Applicable Urban Design Priorities Project Should Achieve

1600 Pacific Ave.

LTV MIXED-USE

1600 Pacific Avenue, Dallas, Texas
maa.2012175 02.19.13

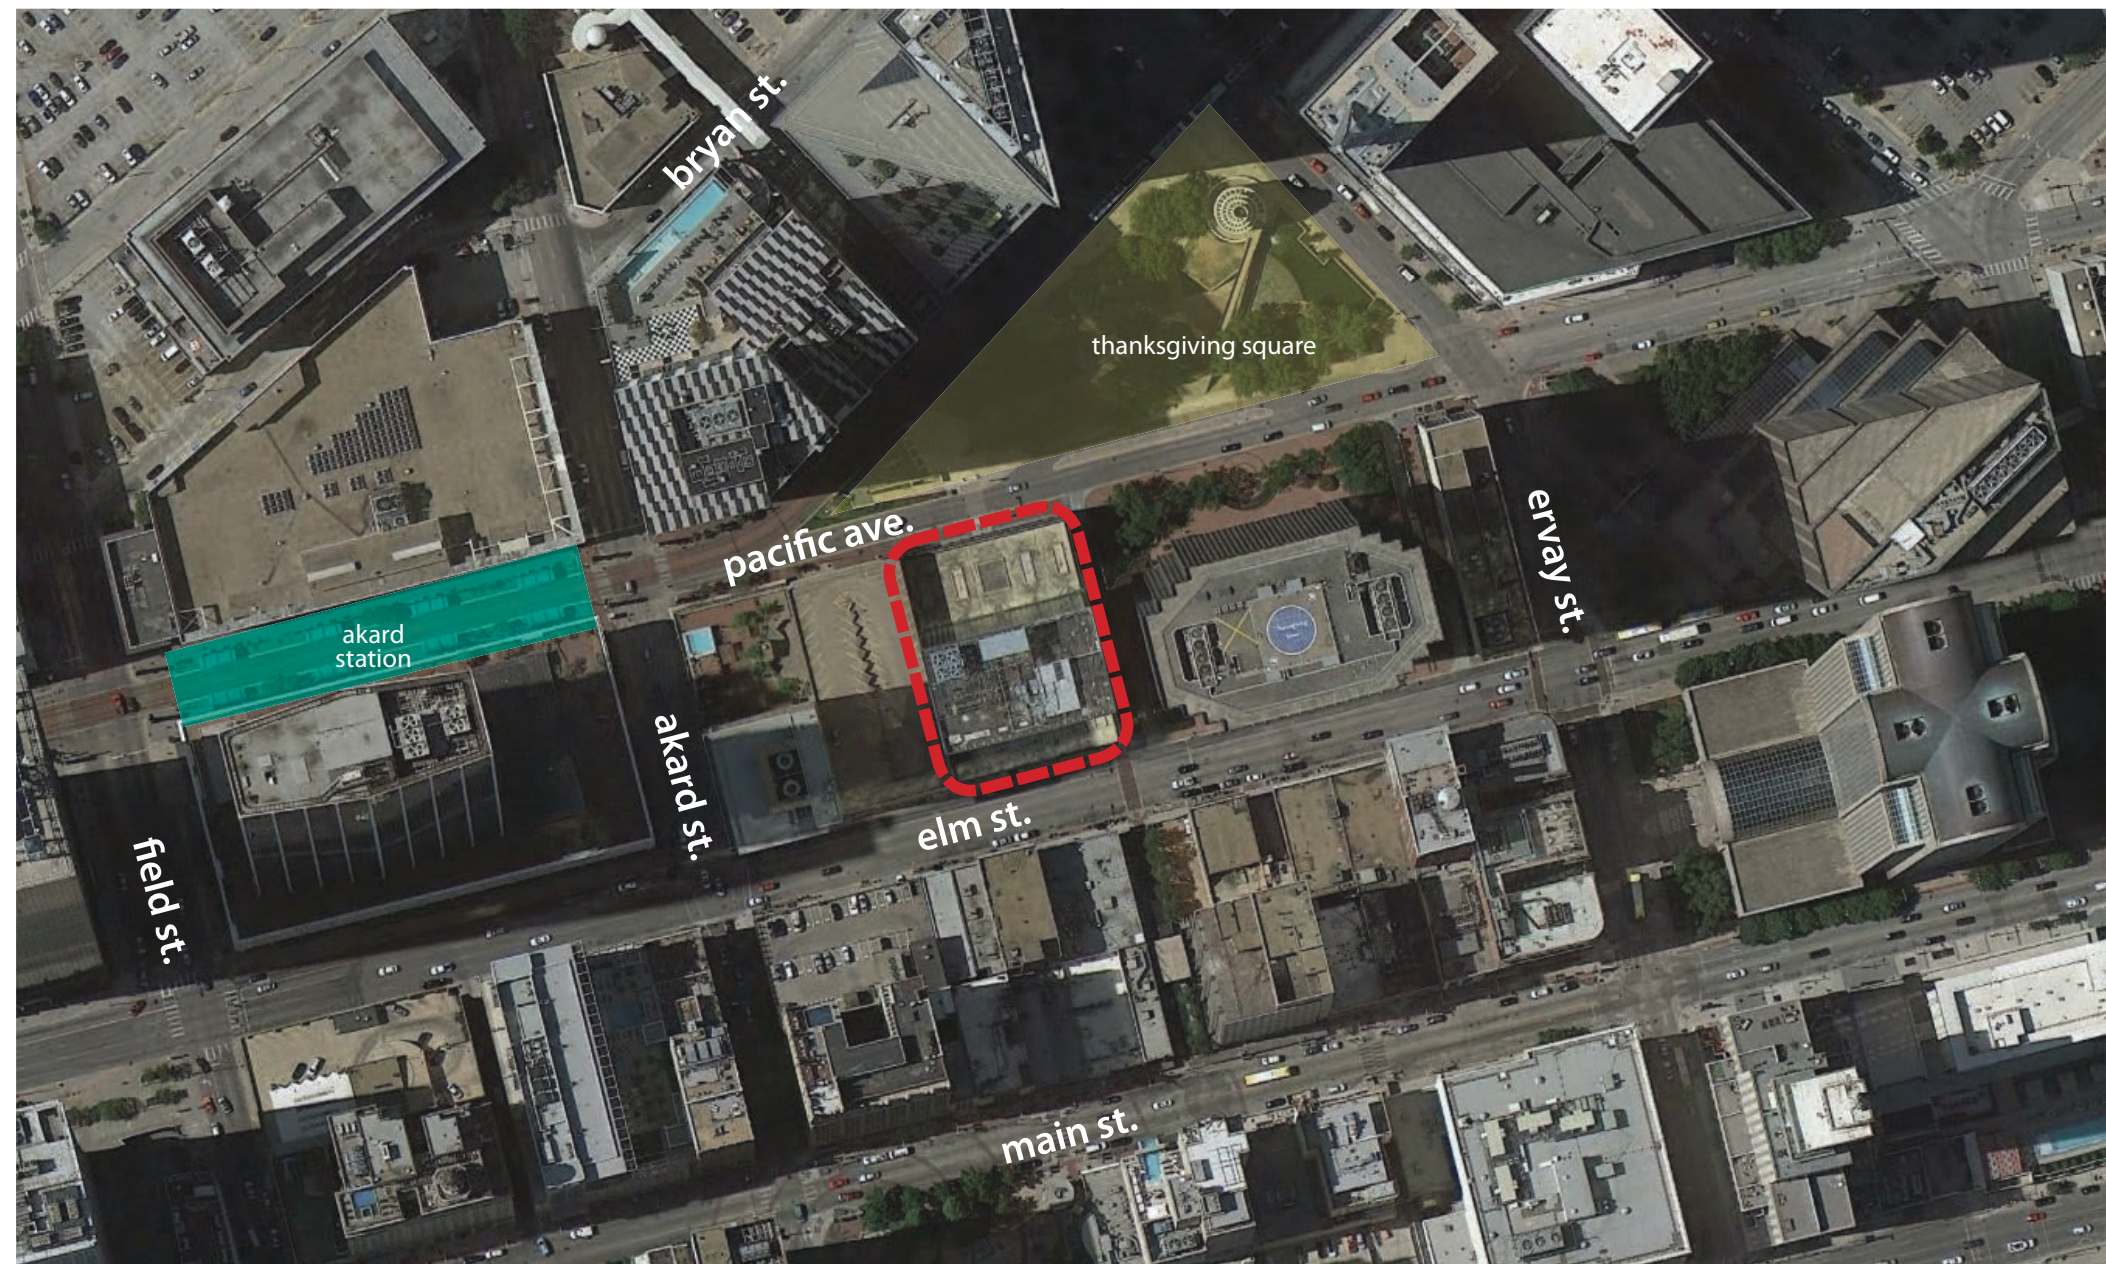
- [1] **Locating hotel drop off on the outer lane of Pacific in favor of a sidewalk and streetscape more consistent with the proposed Elm Street design** - As proposed, the drop off lane on Pacific compromises the pedestrian sidewalk. Valet and drop off lane should relocate to the outer lane of Pacific allowing the sidewalk to be reclaimed for pedestrian use. In order to prioritize the pedestrian over the automobile, sidewalk should be designed to be consistent with Elm design with street trees, generous thoroughway, drives level with sidewalk, and curb cuts occurring outside of the sidewalk thoroughway.

- [2] **Designing all drives as at minimum widths on both Elm and Pacific sides of building** - Drive entries should be designed at the minimum required widths and should be at the same level as the sidewalk along the pedestrian thoroughway. Vehicular curb cuts should occur outside of the pedestrian thoroughway minimizing the impact on the pedestrian.

- [3] **Minimizing and screening all drop off and loading areas** - All drop off and utility zones should be screened and minimized. Design solutions should strive to mask the drives and prioritize the sidewalk thoroughway over the vehicle. Drive should appear as contiguous with sidewalk and mountable by car rather than causing the pedestrian to negotiate the drive.
